HARVEST ROAD

48TH AVENUE TO 56TH AVENUE - INFRASTRUCTURE SITE PLAN

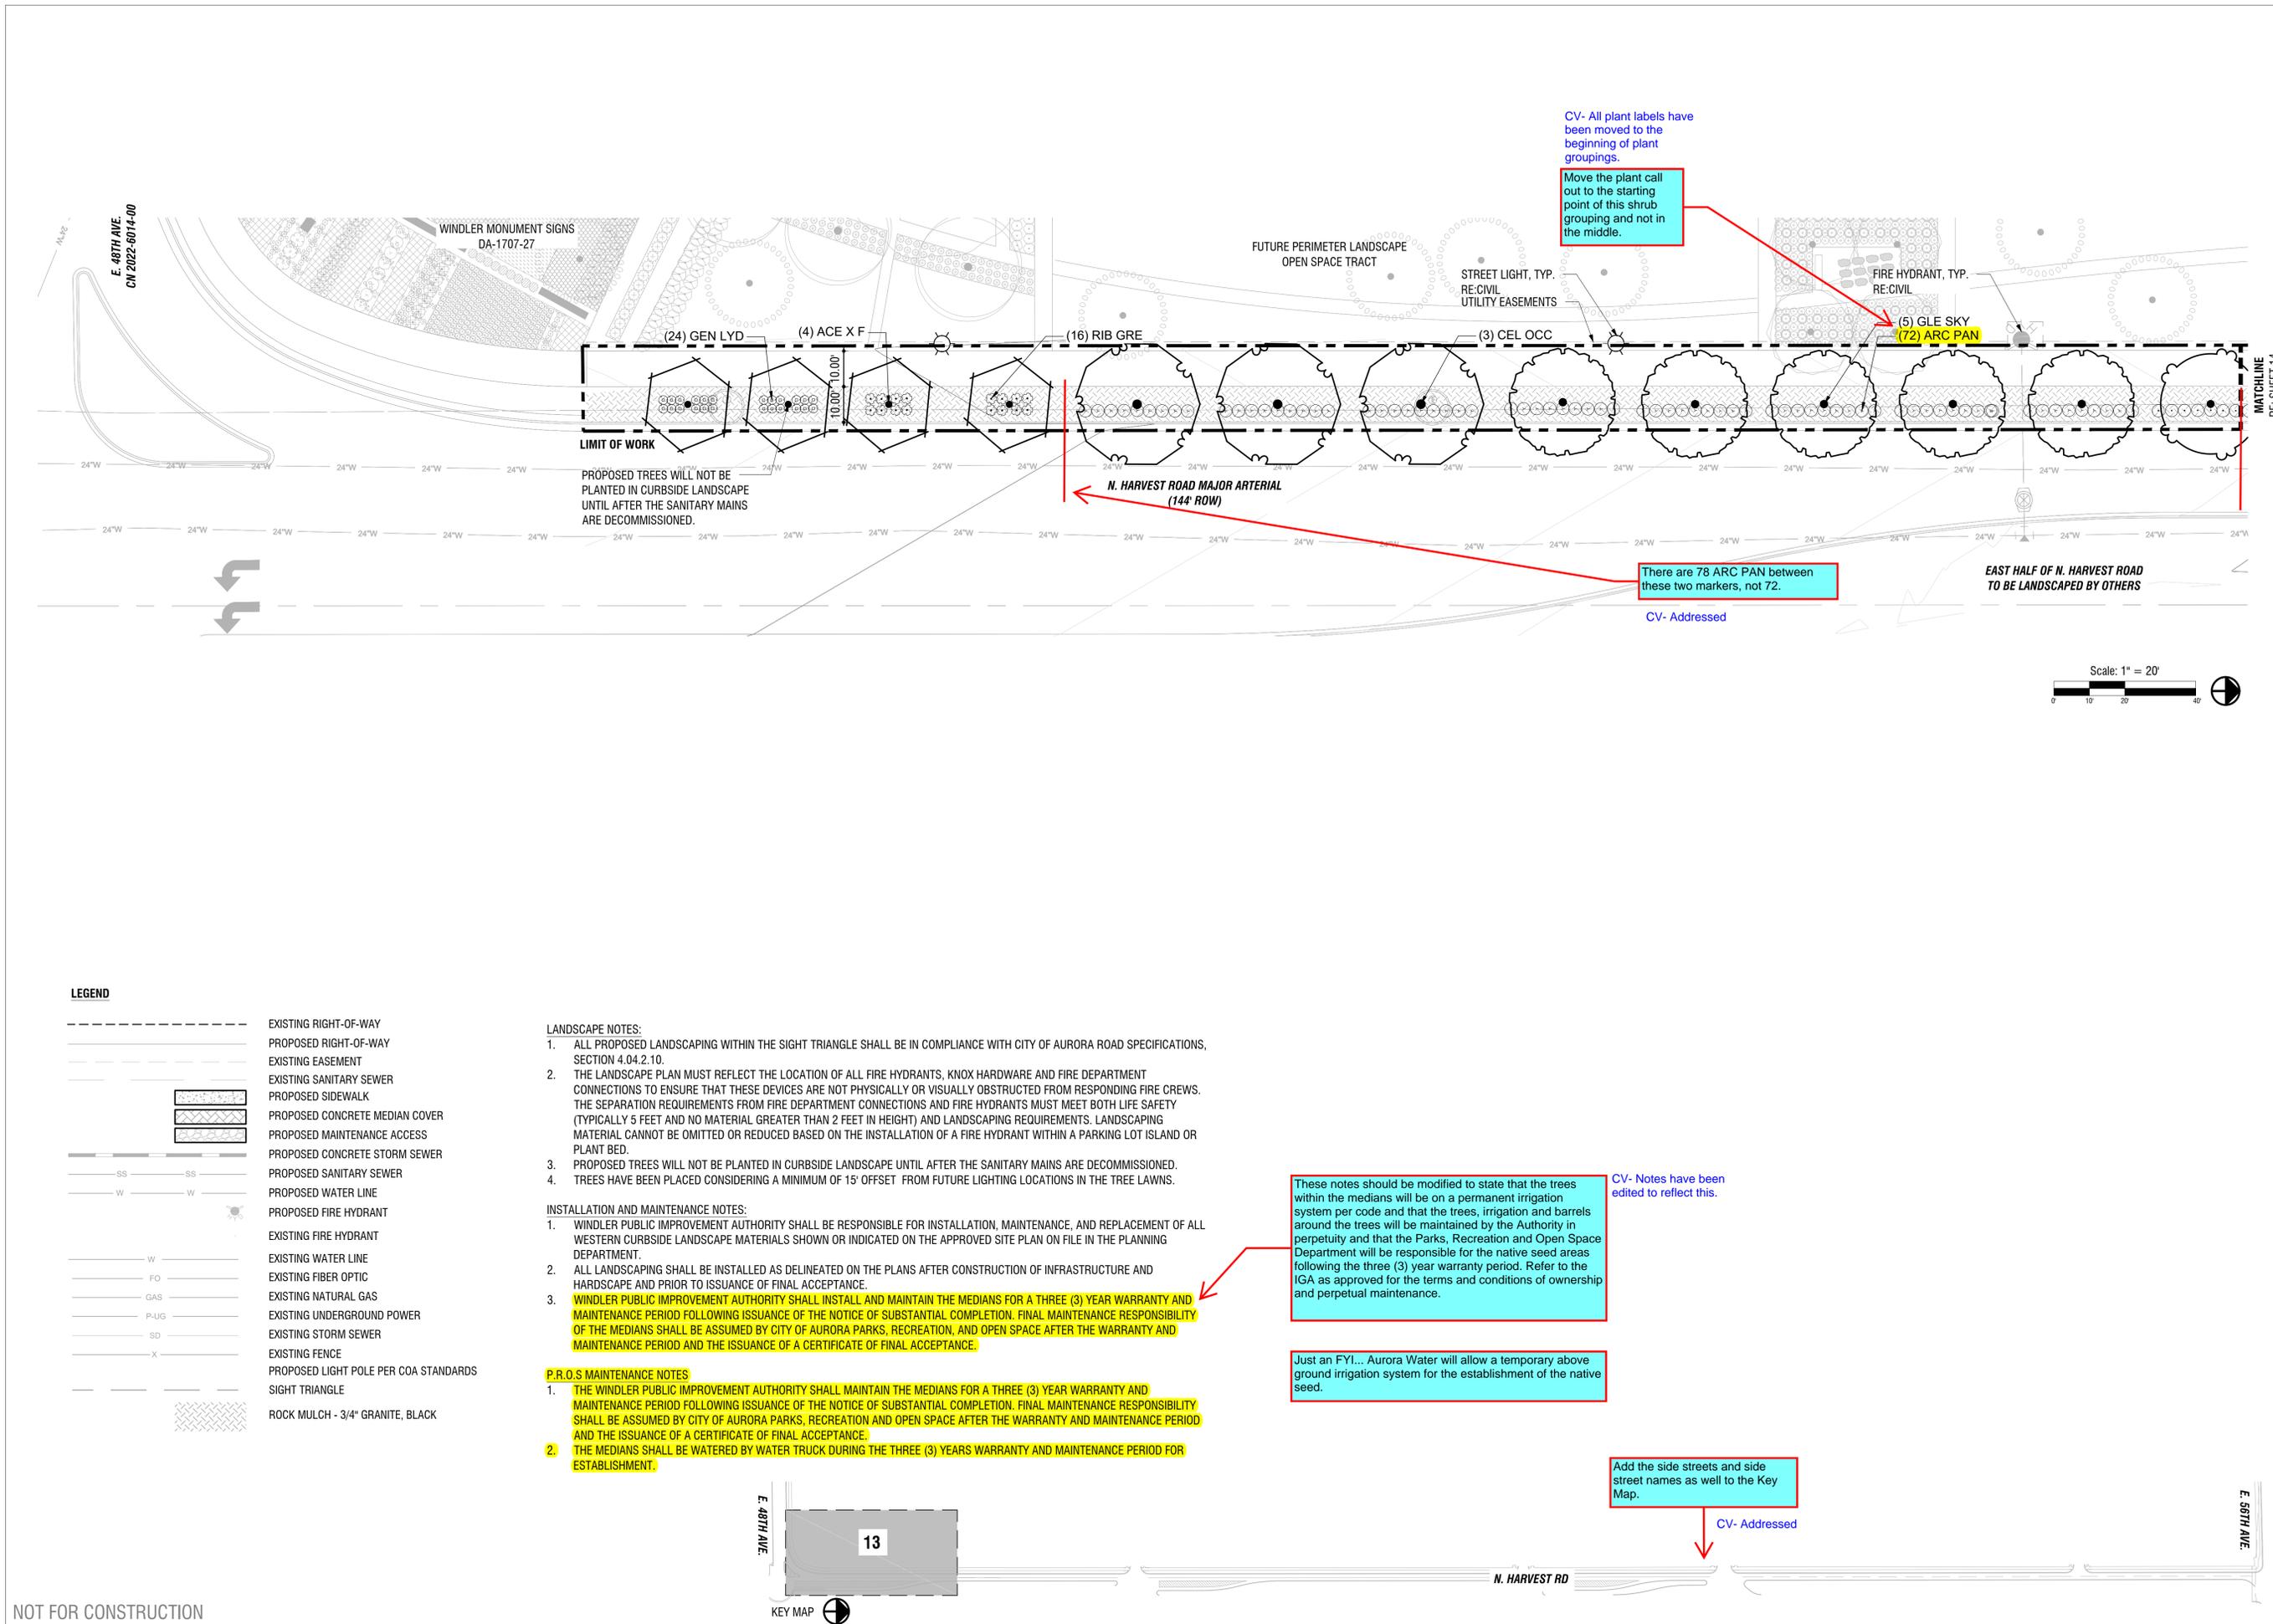
Move the plant call out to the starting point of this shrub grouping and not in the middle.

These notes should be modified to state that the trees within the medians will be on a permanent irrigation system per code and that the trees, irrigation and barrels around the trees will be maintained by the Authority in perpetuity and that the Parks, Recreation and Open Space Department will be responsible for the native seed areas following the three (3) year warranty period. Refer to the IGA as approved for the terms and conditions of ownership and perpetual maintenance.

Add the side streets and side street names as well to the Key Map.

CV- All plant labels have been moved to the beginning of plant groupings.

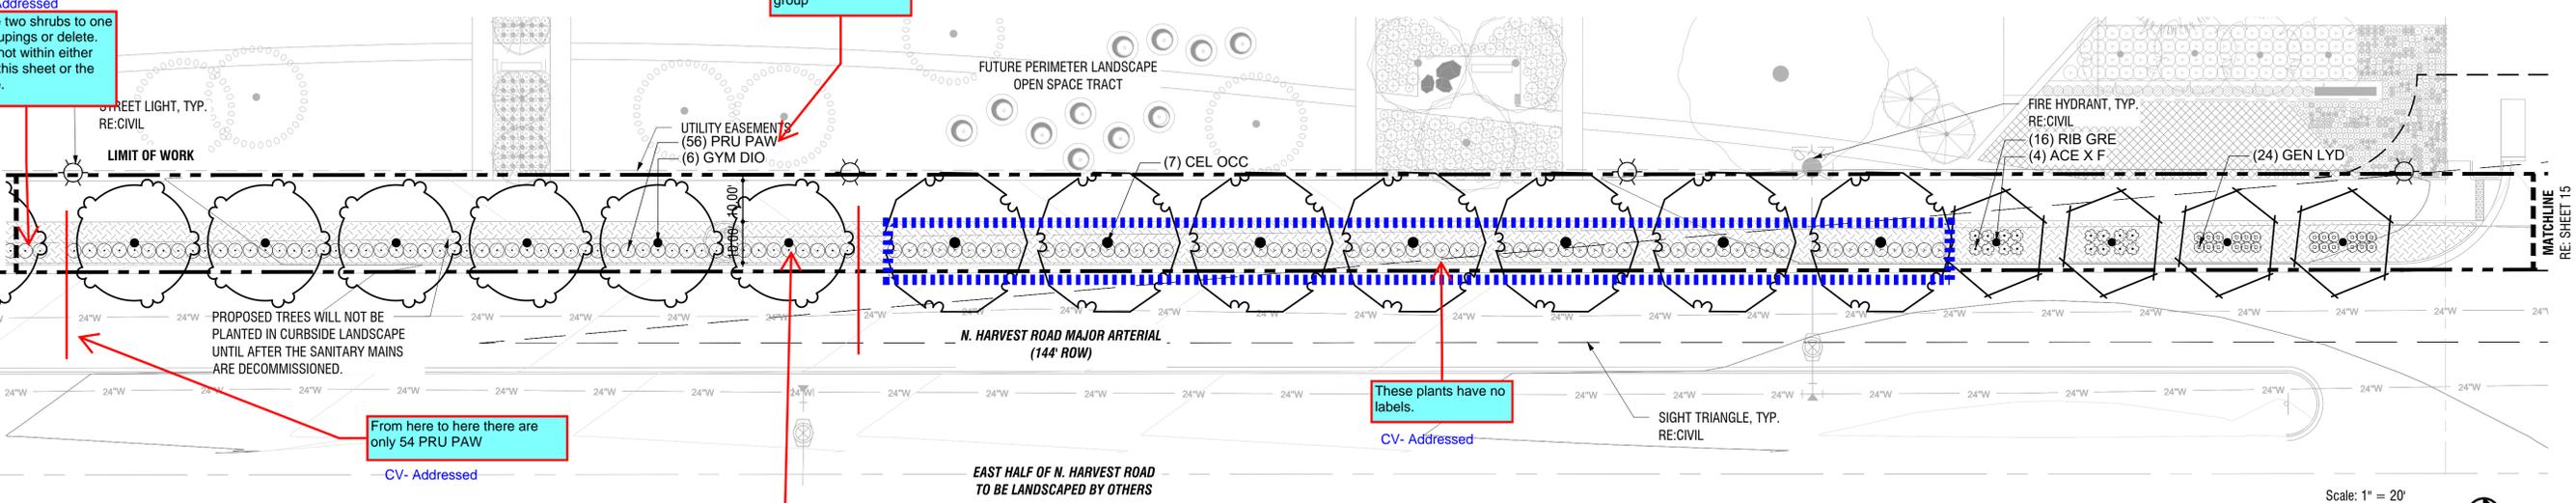
CV- Addressed
Add these two shrubs to one of the groupings or delete. They are not within either group on this sheet or the prior page.

Move the plant call out to where the row of identified shrubs actually starts and not in the middle of the group
CV- All plant labels have been moved to the beginning of plant groupings.

From here to here there are only 54 PRU PAW
CV- Addressed

These plants have no labels.
CV- Addressed

No plant call out. It is part of the tree count.
CV- Addressed

These notes only need to appear once on the initial landscape plan sheet.
CV- Addressed

The UDO requires that the curbside landscape provide a variety of shrub species that differ in height, color and width for visual interest throughout the seasons. The bulk of the shrubs being provided are of only two species that are both ground cover types. Please update the variety of plantings being provided that more accurately meet the intent of the code requirement.

CV- New shrub species have been added to the planting scheme to meet intent of code requirement.

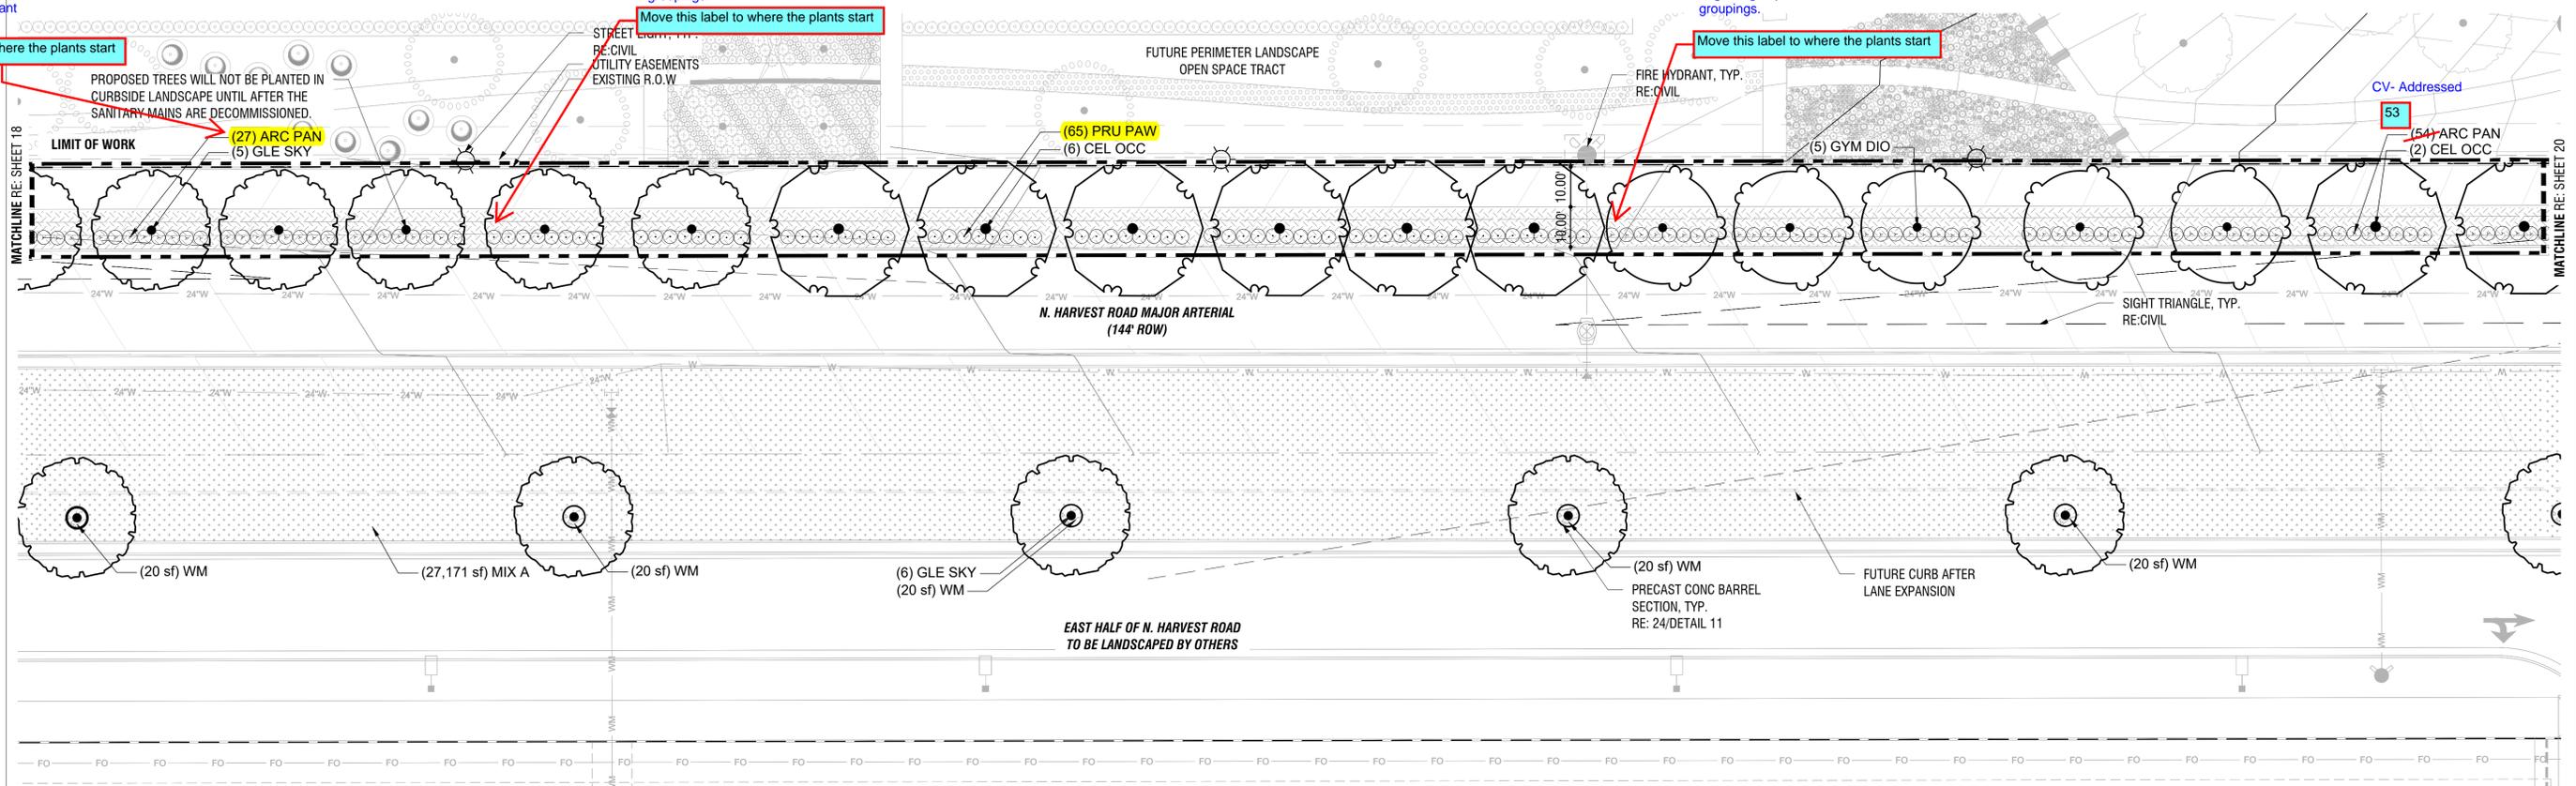
Move this label to where the plants start

Move this label to where the plants start

Move this label to where the plants start

CV- All plant labels have been moved to the beginning of plant groupings.

CV- Addressed

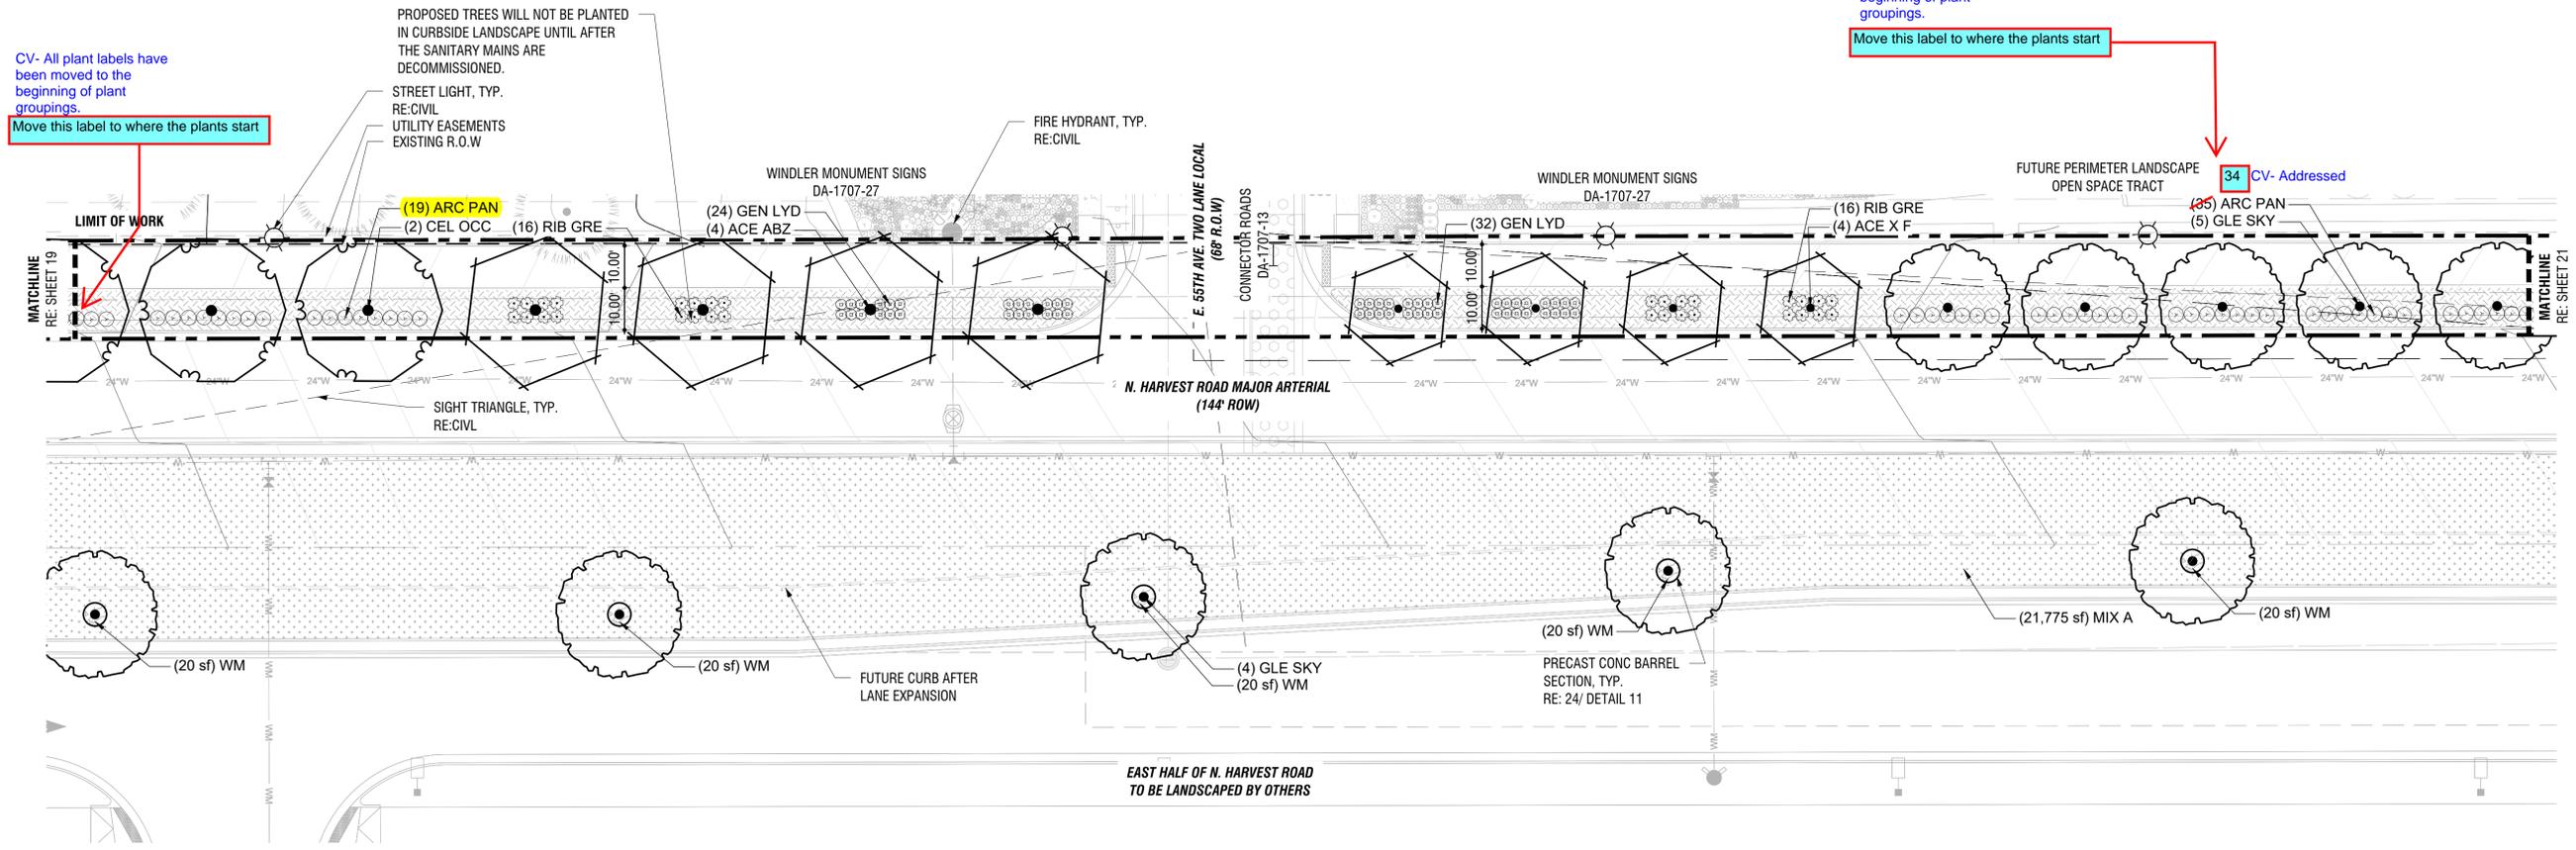
CV- All plant labels have been moved to the beginning of plant groupings.
Move this label to where the plants start

CV- All plant labels have been moved to the beginning of plant groupings.
Move this label to where the plants start
